# SERVICE **No. 1141** BULLETIN

Date: December 9, 2003

### **CLIP NUT REPLACEMENT**

PA-28-161 Warrior III  
PA-28-181 Archer III  
PA-28R-201 Arrow  
PA-32R-301 Saratoga II HP  
PA-32R-301T Saratoga II TC  
PA-34-220T Seneca V

Typical Tail Cone  
Figure 1

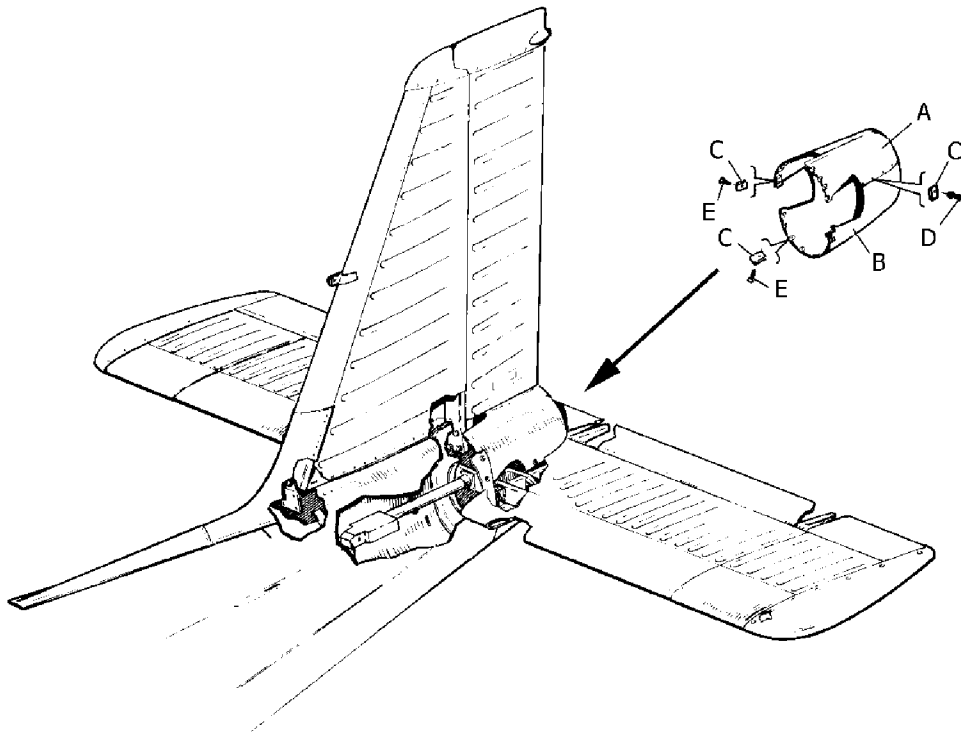
It has been discovered that the above noted aircraft were delivered with tail cone fairing attachment clip nuts installed that did not incorporate a thread locking feature that prevents the fairing mounting screws from loosening and backing out. If the screws were to loosen and fall out, the displaced fairing may interfere with the operation of the horizontal stabilator.

1. Remove the 16 screws, P/N 415-378, (MS51957-45) (Figure 1, Item E) securing the tail cone fairings to the aft end of the fuselage. Remove the 10 screws, P/N 410-054, (MS24694-C5) (Figure 1, Item D) securing the upper tail cone fairing (Figure 1, Item A) to the lower tail cone fairing (Figure 1, Item B).
2. Remove and replace the 26 clip nuts, P/N 477-640, (Figure 1, Item C) from the fuselage and the upper and lower tail cone fairings, ensuring that the replacement clip nuts have a 'thread locking' feature.
3. Reassemble the upper and lower tail cone fairings and re-install the tail cone fairing using the appropriate screws previously removed.
4. Make a logbook entry indicating compliance with this Service Bulletin.

**MATERIAL REQUIRED:** Twenty six (26) each, Clip Nut, Piper part number 477-640, per aircraft.
